CITY OF WESTMINSTER			
PLANNING APPLICATIONS SUB-COMMITTEE	Date 16 May 2017	Classification For General Release	
Report of Director of Planning		Ward(s) involved Lancaster Gate	
Subject of Report	Whiteleys Centre, Queensway, W2 4YH,		
Proposal	Variation of Condition 1 and removal of Condition 10 of planning permission dated 27 April 2016 (RN: 15/10072/FULL) for: Demolition of and redevelopment of building behind retained and refurbished facades to Queensway and Porchester Gardens facades to provide a mixed use development comprising three basement levels, ground floor and up to 10 upper floor levels, containing up to 103 residential units (Class C3), retail floorspace (Class A1 and A3) facing Queensway and arranged around a new retail arcade below re-provided central atrium and central retail courtyard, public car park, hotel (Class C1), cinema (Class D2) gym (Class D2), crèche (Class D1), with associated landscaping and public realm improvements, provision of 103 basement residential parking spaces, cycle parking and associated basement level plant and servicing provision. NAMELY, to reduce the height of the front (Queensway frontage) of the building by 1.5m, reduce the two rear to

Cross section
 Planning Application Consented Scheme and Current Scheme comparison

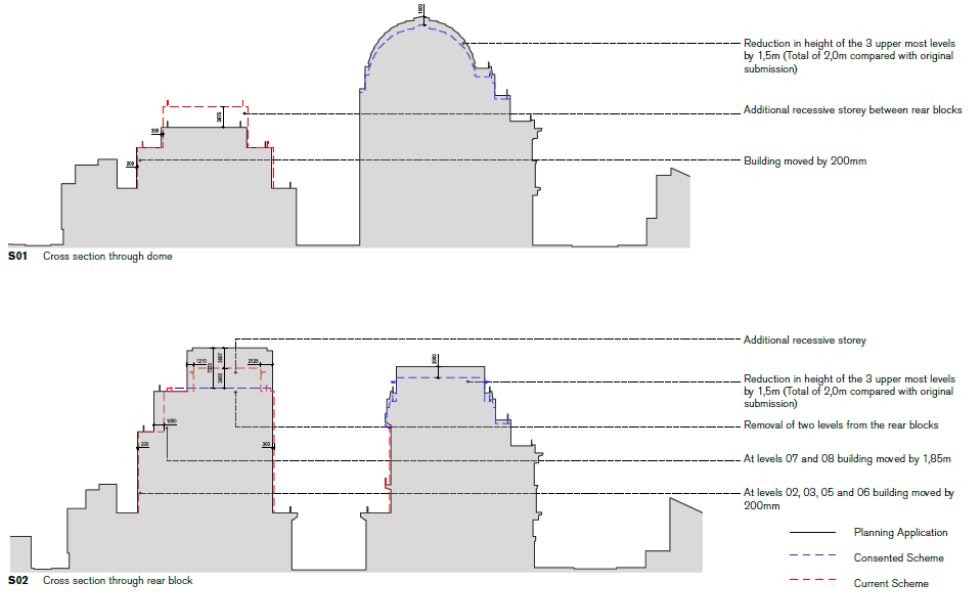
As approved scheme with requirements of conditions imposed in April 2016 shown by blue dotted lines and proposed scheme shown by red dotted lines.

Location and extent of retail floorspace in approved scheme (top) and as now approved scheme (bottom).

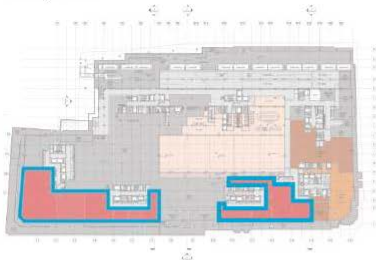
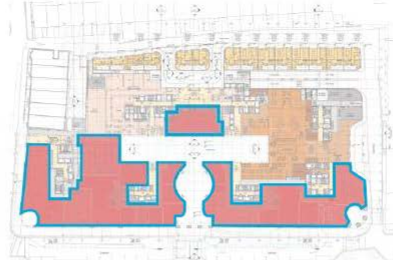
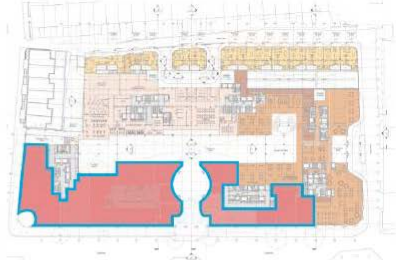
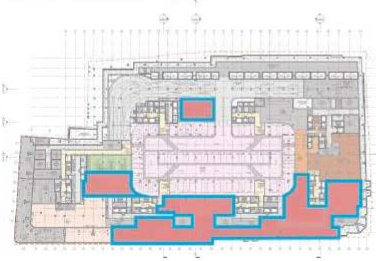
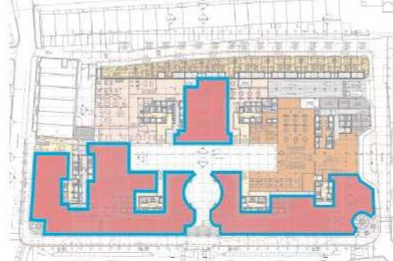
The proposed scheme seeks to replace much of the retail floorspace at first floor level in the approved scheme with an increase in gym floorspace. The increase in gym floorspace is supported by Policy S34, which encourages the provision of social and community uses, and therefore the enlarged gym unit is acceptable in land use terms.

As approved Queensway elevation (top) and as now proposed Queensway elevation (bottom).

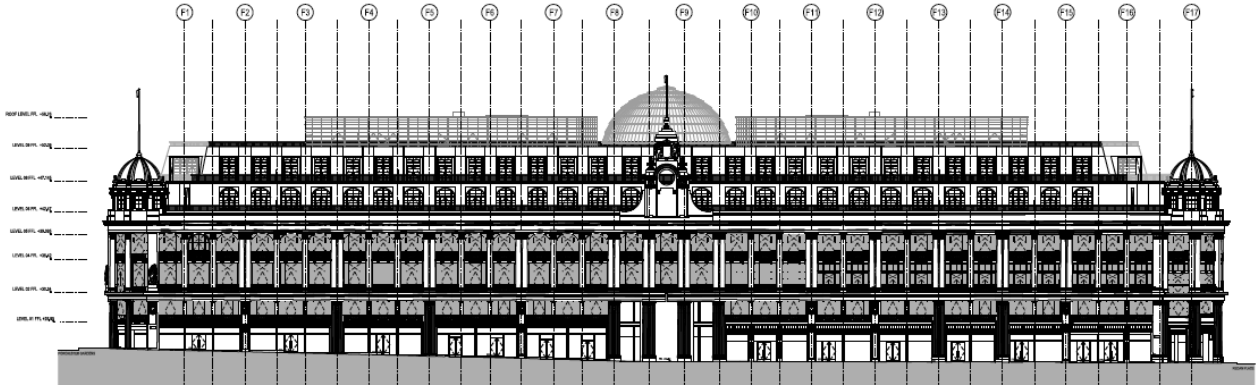
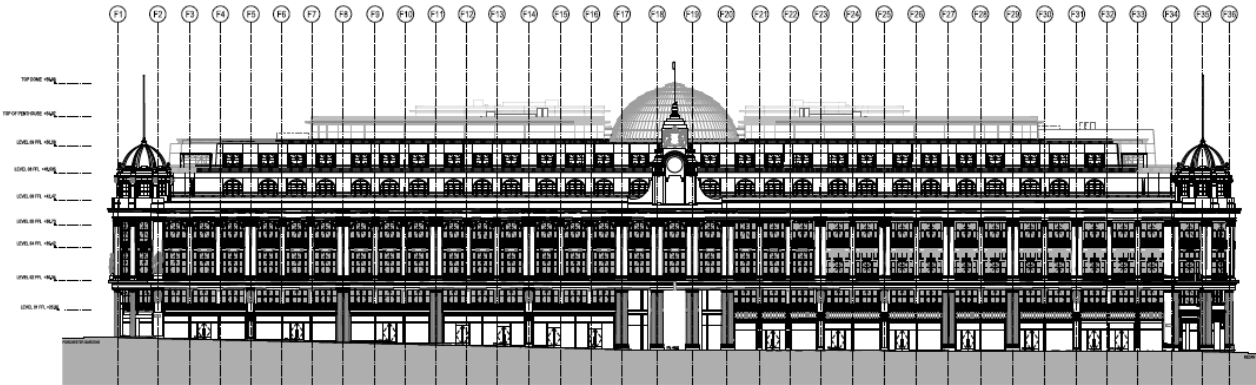
- The submitted drawings show an overall reduction in height of Levels 6-8 to the Queensway elevation is only 0.61m rather than the 1.5m required.
- Omission of vehicular drop off makes Redan Place elevation heavier less relieved.

As approved north (Redan Place) elevation (top) and as now proposed north (Redan Place) elevation (bottom).

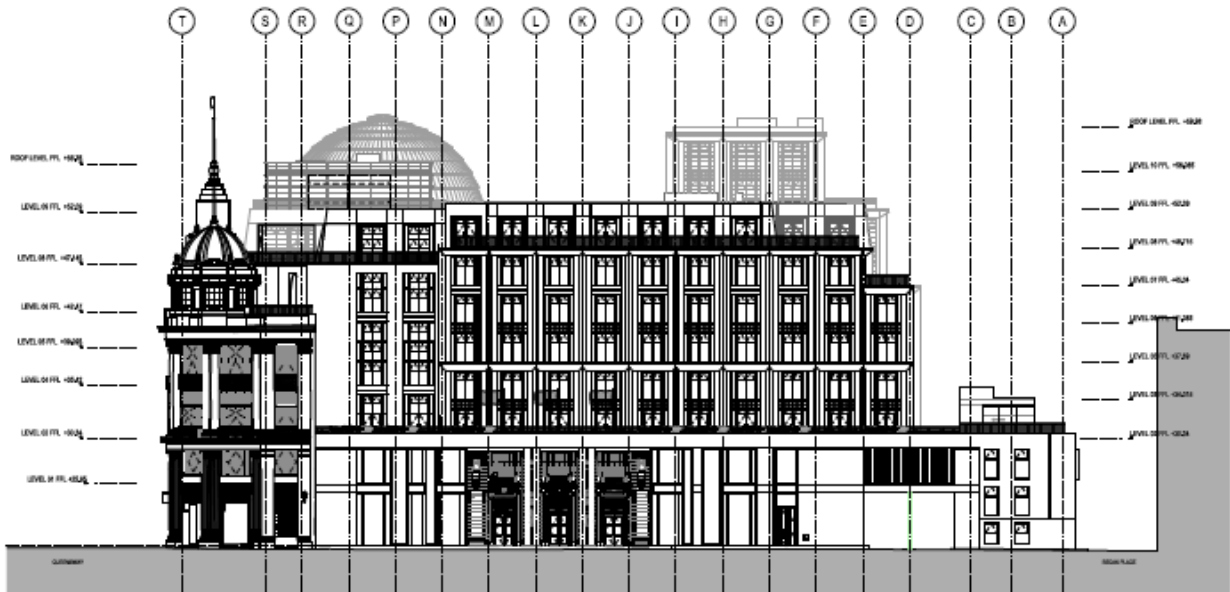
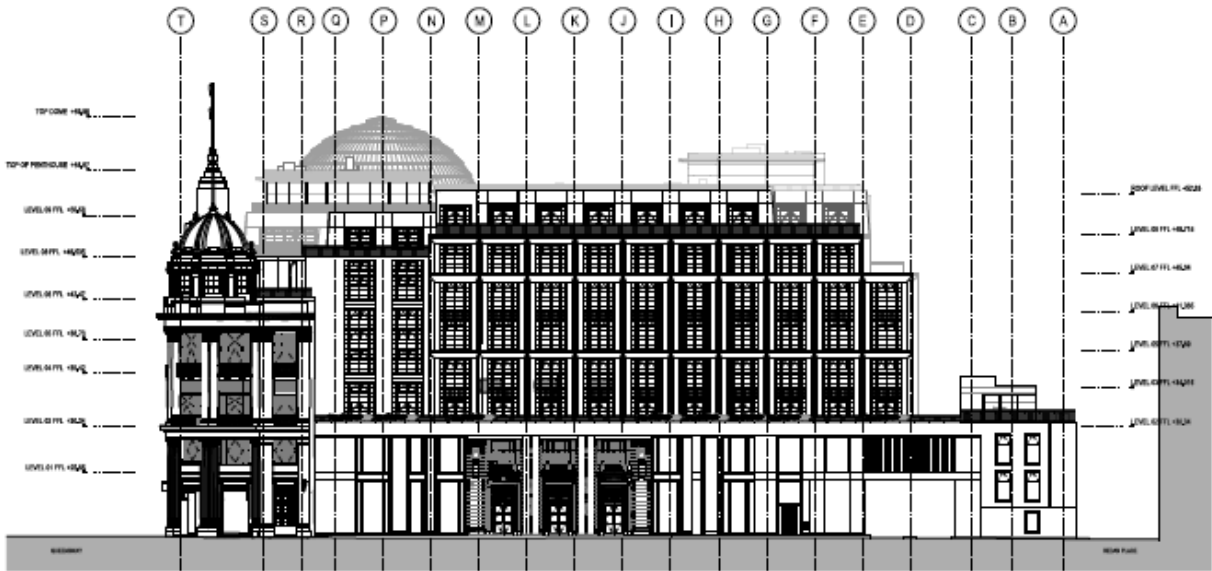
The architectural approach to the facades of the townhouses in Redan Place has been modified and this includes the omission of previously approved projecting bay windows, in favour of smaller window openings set within the front facades. This amendment will assist in reducing the perception of being overlooked by these new dwellings for people living in Kensington Gardens Square and Redan Place.

Montage of proposed 'Tower Pavilions' to rear 'towers'

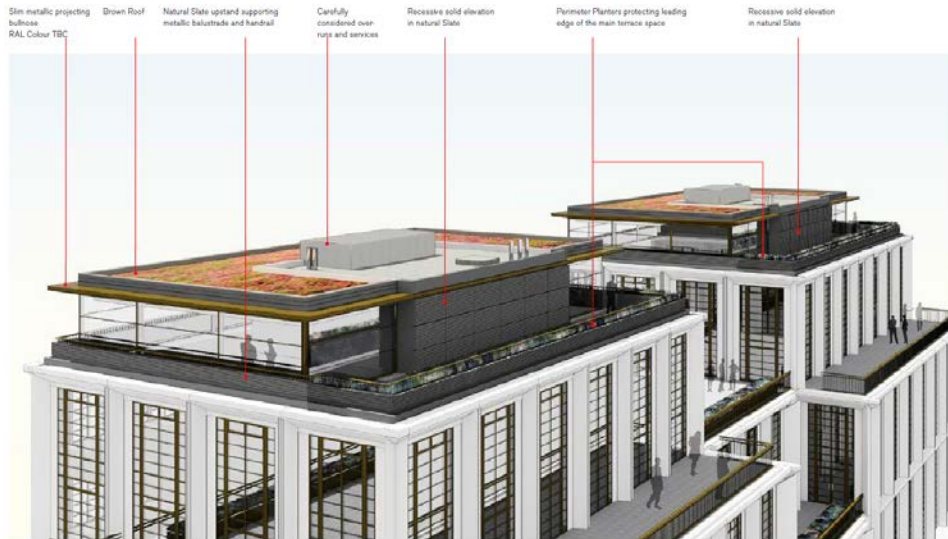
design of the pavilion is more subdued and recessive as now proposed; and (iii) there is a dense screen of trees, which reduce the visual impact even in winter when the trees are not in leaf, it is thus considered that while a full two storeys have not been removed from the tower elements to the rear of the development, as required by Condition 10 part (iv), the amendments have succeeded in significantly mitigating the previously identified harm. In its revised form there remains a degree of harm; however, this harm to the character and appearance of Bayswater Conservation Area and the setting of neighbouring listed buildings is considered to be of capable of being out-weighed by the wider public benefits that the scheme delivers.

As approved section (top) and as now proposed section (bottom) showing additional basement excavation proposed.

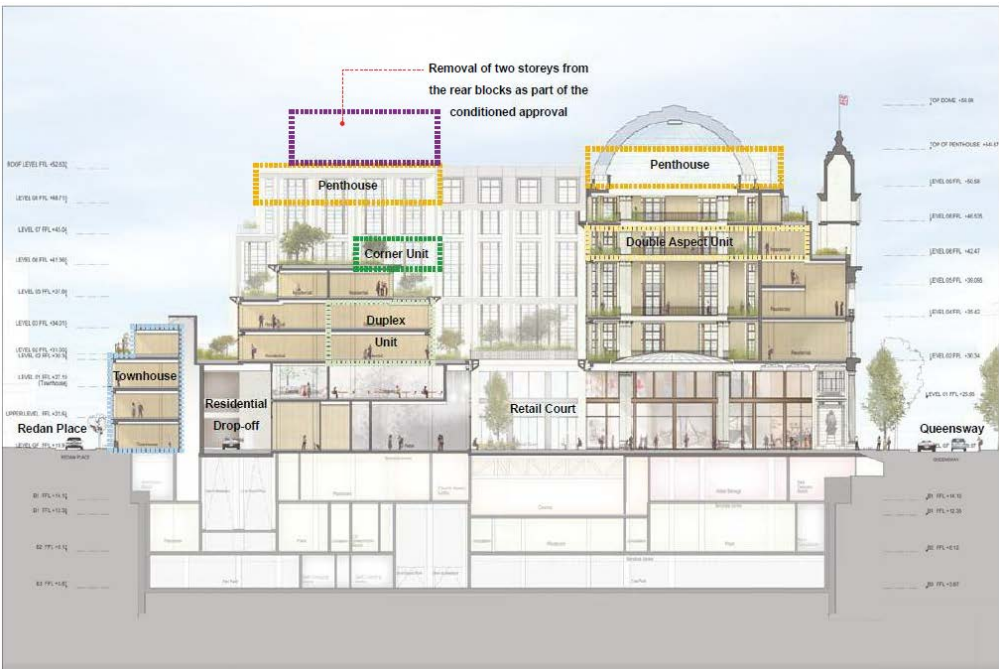
The proposed basement in the amended scheme comprises almost entire site coverage, as was the case in the approved scheme, but proposes additional excavation to accommodate additional back of house/ ancillary floorspace at basement level (such as plant rooms, parking and storage), as well as accommodate additional floor to ceiling height for the proposed cinema accommodation so that it has the flexibility to respond to market demand, such as to provide IMAX screens. The additional excavation proposed ranges between 5.5 metres and 8.5 metres, with the deepest areas of additional excavation proposed towards the centre of the site.
